STAFF REPORT

Case: RCC17-12: Newman

Request: A request for approval, as required per Section 12.06.003(b)(1)

Location: 125 East Concho Avenue; generally located approximately 175

Canopy Color Rendering

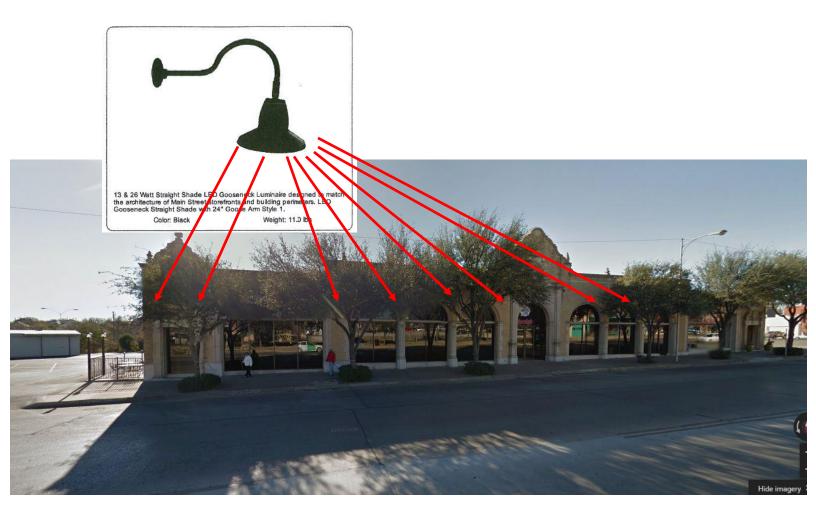
The *RCMDP* guidelines encourages awnings that "serve as a transition between the building, sidewalk and street, helping visually unite them, and providing pedestrian scale to the street." The Historic CBD policies consider a metal canopy provided it is "similar to those seen traditionally" and that the proposed colors should "complement neighboring buildings and reflect a traditional color palette."

The proposed metal canopy appears to be consistent with all of the above policies. It will cover the existing outdoor patio, providing an effective transition between the restaurant, sidewalk, and parking lot and an attractive exterior feature and shade cover. The canopy will be of quality metal construction and painted black to match

the existing metal patio railing and exterior light pole fixtures. This Board recently approved a canopy of similar color, style, and construction at 38 North Chadbourne Street, which will utilize the same metal exterior roof design (RCC16-14).

- 1. All proposed colors and materials shall be consistent with the renderings approved by the Design and Historic Review Commission.
- 2. The applicant shall obtain a Building Permit for all improvements as required, from the Permits and Inspections Division.
- The applicant shall install and use only LED light(s) inside the proposed sign, consistent with previous approvals. A lighting sample shall be provided to the Planning and Development Services Director prior to issuance of a sign permit.

Sign Details

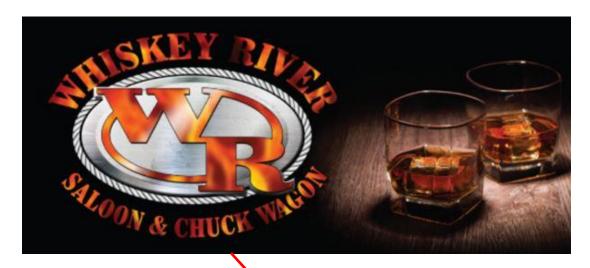
The proposed flex-face lit sign will be comprised of a historic font with dark orange letters, a black and white background, and an image of two whiskey glasses. Planning Staff believes that the proposed design is consistent with the West Texas saloon theme, and that the solid, neutral colors are appropriate for the River Corridor and consistent with other signage along East Concho Avenue. However, Staff recommends that the applicant install an LED bulb to reduce spillover glare on nearby properties, including a residential dwelling located directly north of the property at 128 East Concho Drive. The LED design would also be consistent with the proposed gooseneck lighting located above the front building wall.

While Staff believes that the sign design and colors will be appropriate for the existing building and surrounding area, Staff does not believe an internally-illuminated sign without an LED light to control light spill is appropriate. Recent, previous Commission approvals RCC12-02 and RCC13-04 required internally lit-signs on the grounds that the existing sign was legal non-conforming. Staff does not believe the intent of this provision, which refers to a non-conforming sign as "Any permanently installed sign which existed at the time of adoption of this article that was legally erected prior to enactment of this article but fails to conform to the provisions specified herein shall be regarded as a nonconforming sign" was meant to apply to sign faces being replaced. The pole and bracket of the sign would be entitled to legal non-conformity as there are no changes to these structures. However, adding an entirely new sign face with new colors, lettering and design should be subject to the current regulations and policies.

Since that time, Staff have consistently been requiring signs in the River Corridor to use an LED design which can control light spill, and the DHRC has concurred. The requirement of an LED design or equivalent has been a condition of approval for at least the past three years. As downtown San Angelo continues to develop, consistency and compatibility with the historical character of downtown is paramount. So much so, that City Council created restrictions in the Sign Ordinance for signs in the River Corridor for that very reason, as stipulated in the Ordinance intent statements:
